71-3076

**Subject:        Application for Validation of the Canadian Nuclear Safety  
                 Commission Package Design Approval Certificate CDN/2078/B(U)-96  
                 (Rev.0) for the F-458/F-245, F-458/F-247, F-458/F-251, F-458/F-251  
                 MK2, F-458/F-318 and F-458/F-448 Transport Packages**

This letter and the attachments form the response to the US Nuclear Regulatory Commission, Request for Additional Information enclosed in your email of July 20, 2005. The additional information is for Docket No. 71-3076, MDS Nordion model nos. F-458/F-245, F-458/F-247, F-458/F-251, F-458/F-251 MK2, F-458/F-318 and F-458/F-448, Canadian Package Design Certificate No. CDN/2078/B(U)-96.

FIGURE A3-6 SEAL LIFE AT TEMPERATURE

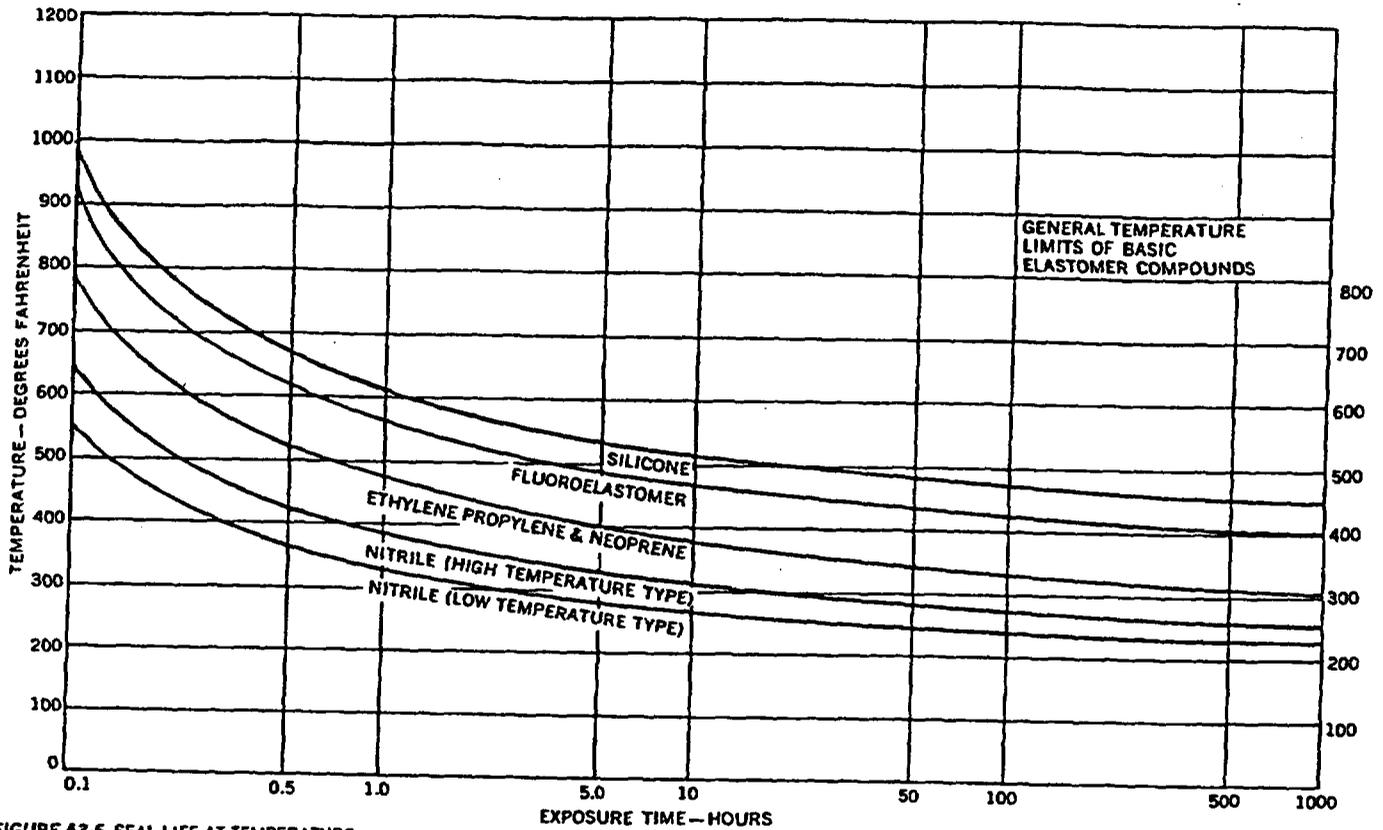
7. Justify the temperature limit of the O-ring in the leakproof insert as being 149 °C as stated in Appendix 11, Section 4.2.3. Considering the uncertainties in the calculation method, justify the conclusion that the O-ring is suitable for the Hypothetical Accident Condition fire.

The calculated maximum temperature of the O-ring is 133°C (refer to Section 7.2 of Addendum 11D). Appendix 2.1 drawings show the O-ring as neoprene. The 1992 edition of the Parker O-ring Handbook, page A3-35, shows the upper normal temperature range of a neoprene O-ring as 121 °C, with a short term temperature limit of 135 °C.

The temperature limit of 149°C for the O-ring in the leakproof insert is derived from Figure A3-6 in Appendix C. The O-ring seal is specified as a "Parker [REDACTED] or equivalent" [REDACTED] O-ring. Per the manufacturer's product handbook, the service temperature is -43°C to +150°C (-45°F to +300°F) per Table A3-13. From Figure A3-6, at 1000 hours, [REDACTED] has a temperature limit of 300°F that corresponds to the service temperature from Table A3-13 for Parker compound [REDACTED]. The comment on "Time" in the manufacturer's product handbook, page A3-37 is: "The curves show the safe, cumulative time at a given temperature for specific elastomers used as static seals. For dynamic seal applications, temperatures as much as 25 °F (14 °C) below those indicated may be more realistic."

The manufacturer also notes that actual temperature limits will vary based on the application. Figure A3-6 of the Parker handbook, Appendix A, shows that the general seal life at temperature for neoprene is approximately 1 hour at 240°C. Transient temperature excursions outside the normal service temperature range may be sustained by the neoprene. This is applicable to the accident conditions of transport (ACOT), since the elevated temperatures are transient.
